TMDXEVM6670L EVM A102-1 Workaround List at page.21 of the schematics:

TMDXEVM6670L EVM A102-1 Workaround List at page.33 of the schematics:

CLOCK GEN1 (DDR3)

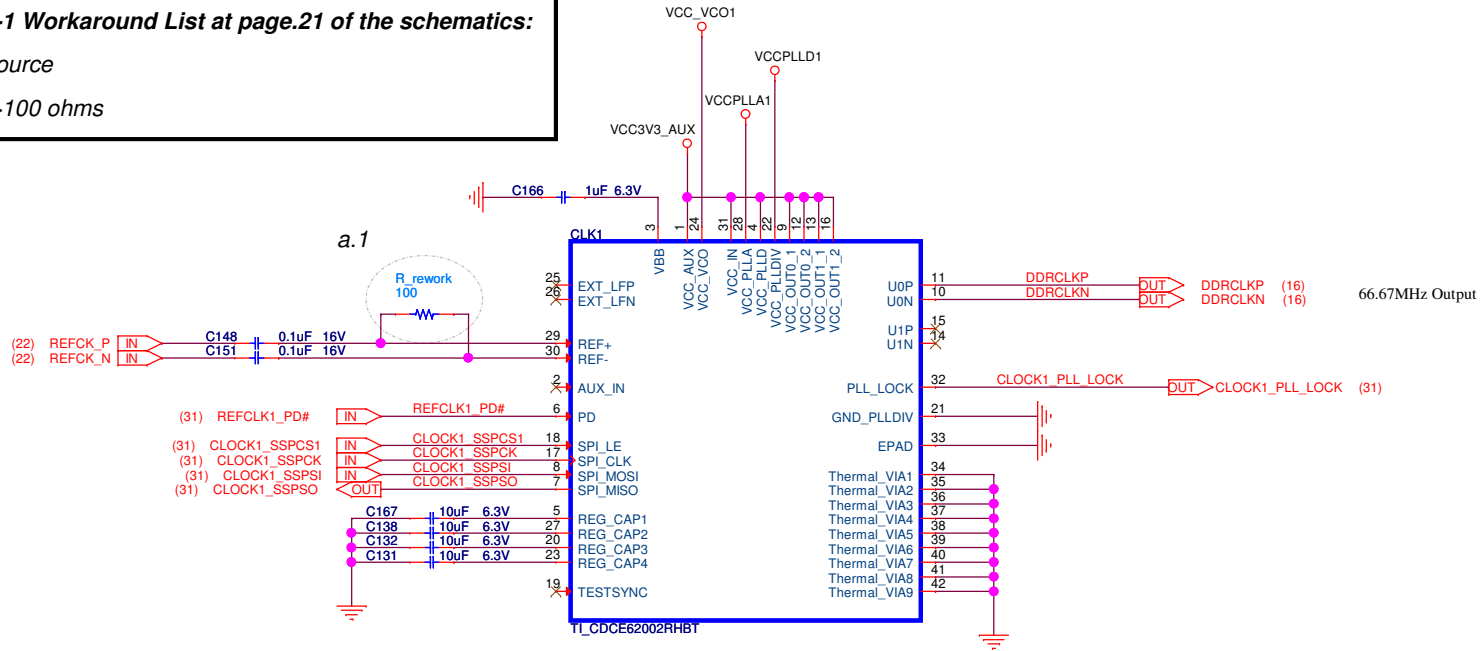
a. Improving the clock source

a.1 Additional R ->100 ohms

CVDD

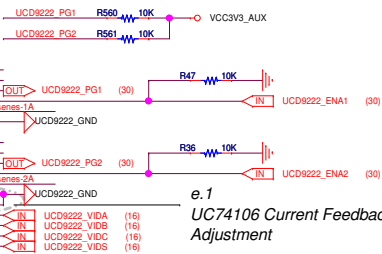
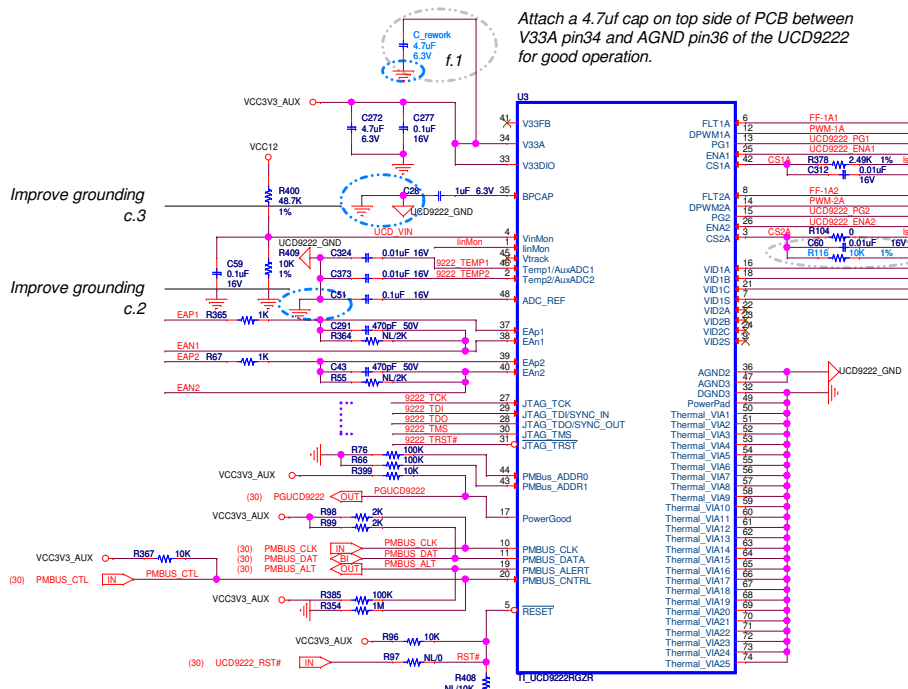
Improve UCD9244 analog power

Attach a 4.7uf cap on top side of PCB between V33A pin34 and AGND pin36 of the UCD9222 for good operation.

Improve grounding
c.3

Improve grounding
c.2

e.1
UC74106 Current Feedback Adjustment

DSP Vcore @9.75A

Improve grounding
c.1

Current Sensing Circuitry Adjustment

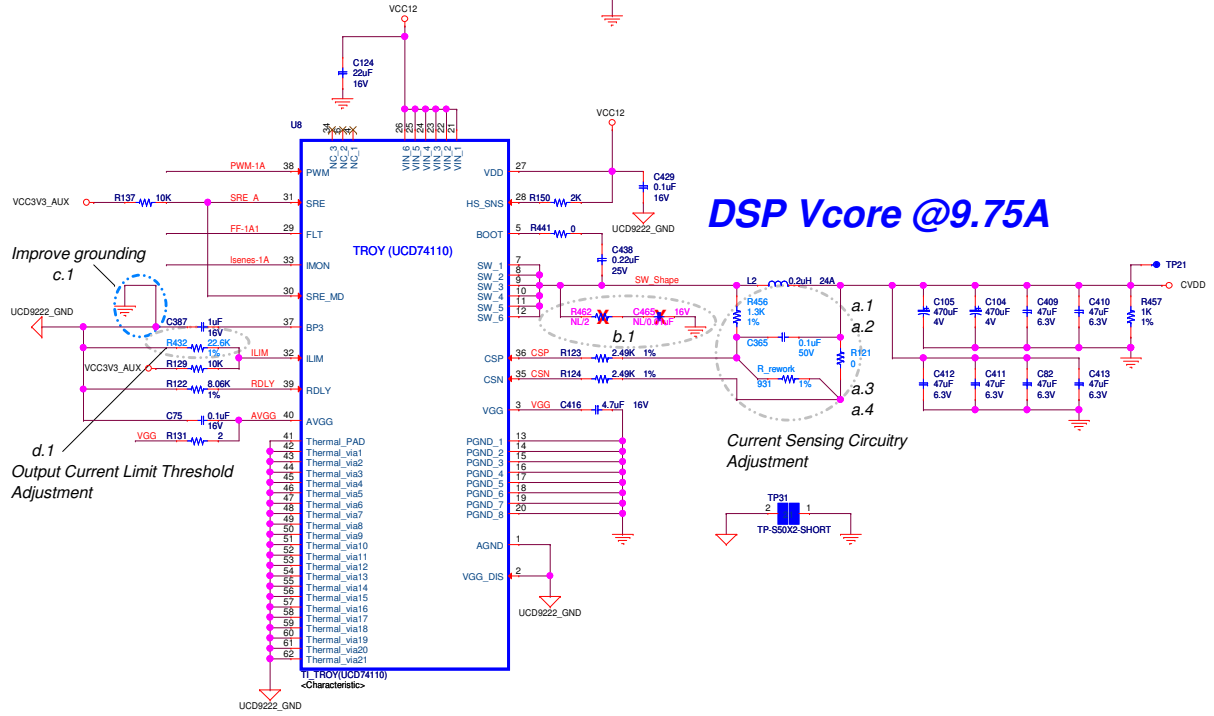
d.1
Output Current Limit Threshold Adjustment

- a. Modify the DCR sensing circuitry of the L2 inductor
 - a.1 R456 -> 1.3k ohms
 - a.2 C365 -> 0.1uf cap
 - a.3 R121 -> 0 ohm
 - a.4 Additional R -> 931 ohms (across the ends of R123 and R124).
- b. Remove the snubber components.
 - b.1 Remove R462, C465.
- c. Improve the grounding on UCD9222_GND plan.

The UCD9222 was halt in POR state, this was caused by the incorrect connection of the 74110 power pad to analog ground.

- c.1 C387 (BP3, the end of UCD9222_GND) -> GND
- c.2 C54 (ADC_REF, the end of UCD9222_GND)-> GND
- c.3 C28 (BPCAP, the end of UCD9222_GND) -> GND

The changes at the BPCAP pin would not have been needed if the attached capacitor was on the same side and located close to the pin.

- d. Output Current Limit Setting Adjustment on UCD74110.
 - d.1 R432 -> 22.6k ohms
- e. Current feedback setting Adjustment on UCD74106.
 - e.1 R116 -> 10k ohms
- f. Improving UCD9222 V33A power supply.

The additional capacitor on the V33A/V33D pin is needed to improve decoupling of this sensitive circuitry.

Note that this would not have been necessary had the available decoupling been implemented adjacent to the UCD9222 on the same side so that vias were not needed.

f.1 Additional C -> 4.7uf between the pins of V33A and AGND on the UCD9222.
